*Comments on the Draft Categorical Exclusion Evaluation*, Princeton Hydro, January 9, 2017

*Headquarters Road Bridge Rehabilitation Preliminary Plans*, Bond, January 11, 2017

*Draft Categorical Exclusion Evaluation*, Meliora Design, January 12, 2017

**Figure 7**  
**One-Lane Bridge Superstructure Replacement and Substructure Rehabilitation (Alternative 3)**  
 S.R. 1012, Section BRC, Headquarters Road Bridge Project  
 Tinicum Township, Bucks County, Pennsylvania

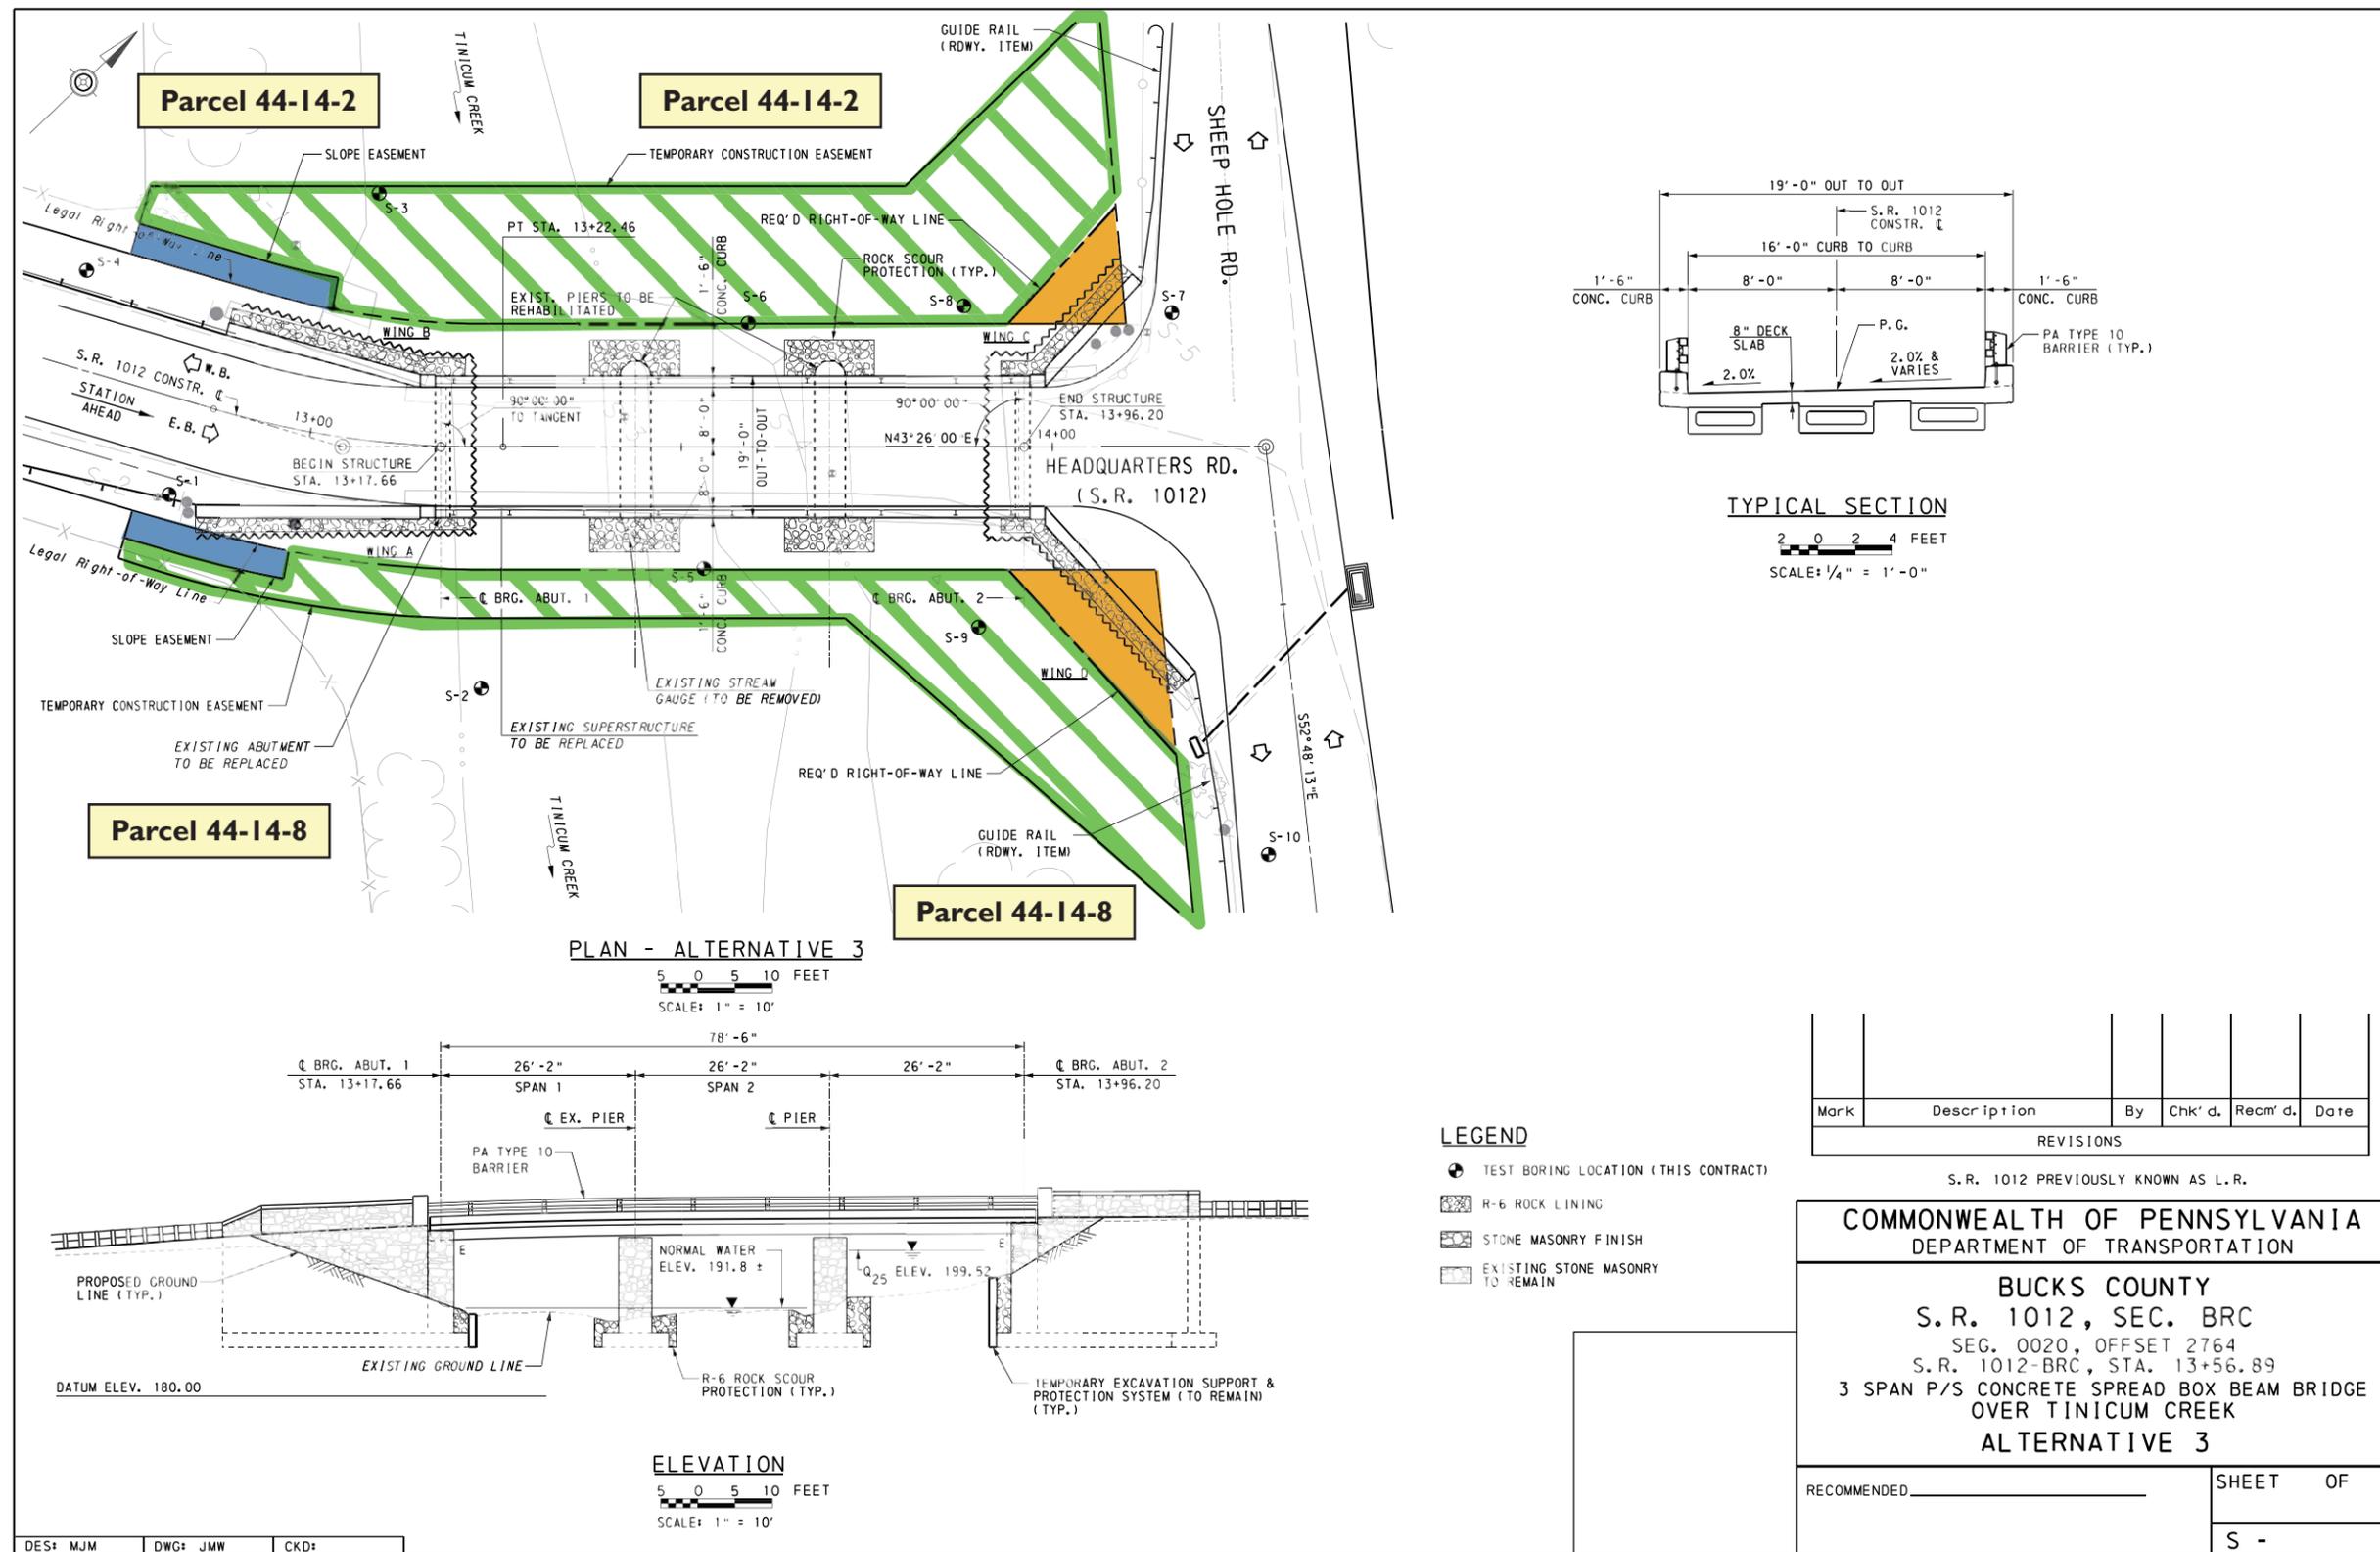
COMMENT #13: Pg 17 – Figure 7 – Alternative 3 – There is a note on the drawing that the existing abutment is to be replaced, but this does not match the text that describes rehabilitation for both piers and abutments. The foundations are shown on the drawing to have a footing but all evidence suggests that the existing piers bear directly on the rock. Also the rip rap shown around the piers and abutments could have a negative effect on historic integrity and stream flow. Other measures should be considered to improve scour protection. There is a note about temporary excavation support and protection system to remain but this is not explained in the text. The elevation of this protection system appears well above normal water and so could negatively impact the bridge. It appears that this protection system extends into the rock below the abutment but this is not explained in the text. There are options available to improve the turning radius that should be explored.

RESPONSE #13: The Determination of Effect Report noted that the bridge abutments would be rehabilitated with Alternative 3. However, due to the extent of abutment deterioration and localized failure, full replacement of the abutments is recommended. This was clarified in additional information provided to the SHPO and the Section 106 consulting parties. The foundations are likely founded on bedrock, although we have observed a concrete collar around some of the units. In the additional information provided to SHPO and the Section 106 consulting parties, the graphic on Figure 7 was revised to show that the abutments will be replaced and the note about the temporary excavation support and protection system was removed.

**Figure 10**  
**Two-Lane Bridge Replacement (Alternative 6)**  
S.R. 1012, Section BRC, Headquarters Road Bridge Project  
Tincum Township, Bucks County, Pennsylvania

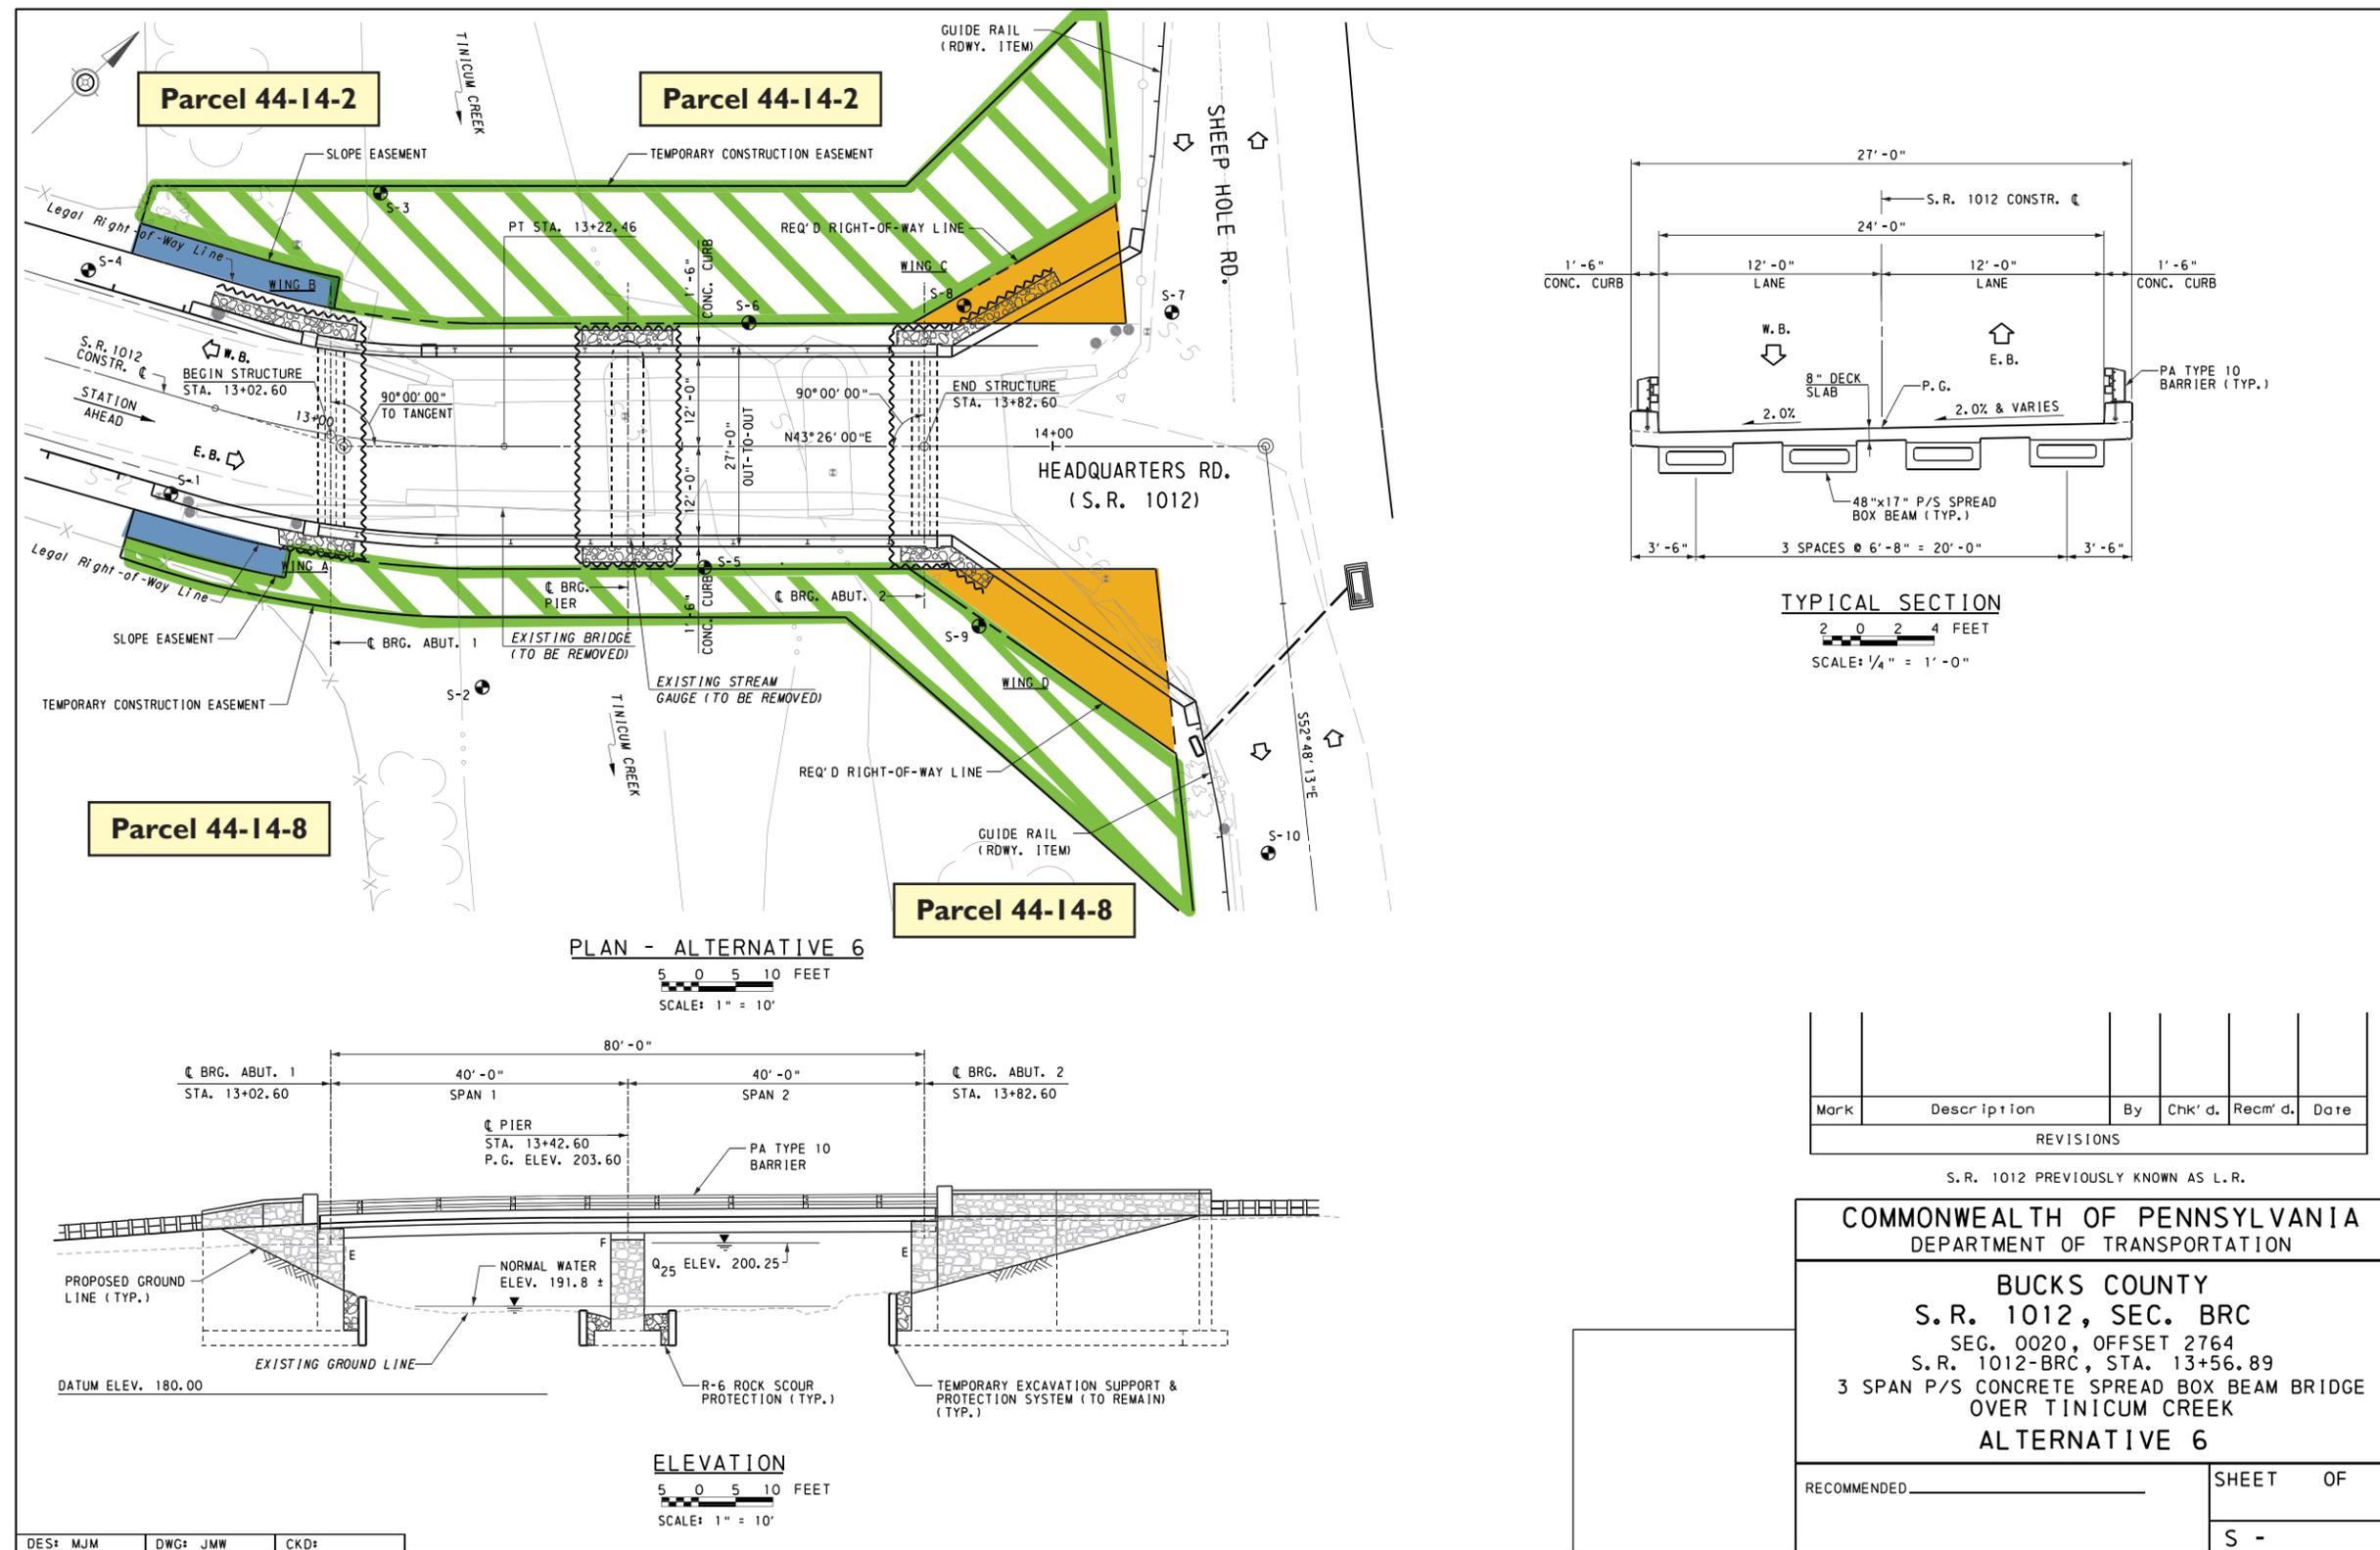
DOE Figure 10) cross sections, the proposed bridge replacement will result in an increase of 0.73 feet in water surface elevation in the 25-year event.

The hydrologic and hydraulic analysis prepared by Urban Engineers in February 2012 includes a summary table which contradicts the information provided in the DOE on Figure 10. The water surface elevation reported for the 25-year event on Figure 10 is 200.25, which does not appear in the detailed hydrologic analysis prepared by Urban Engineers in 2012.
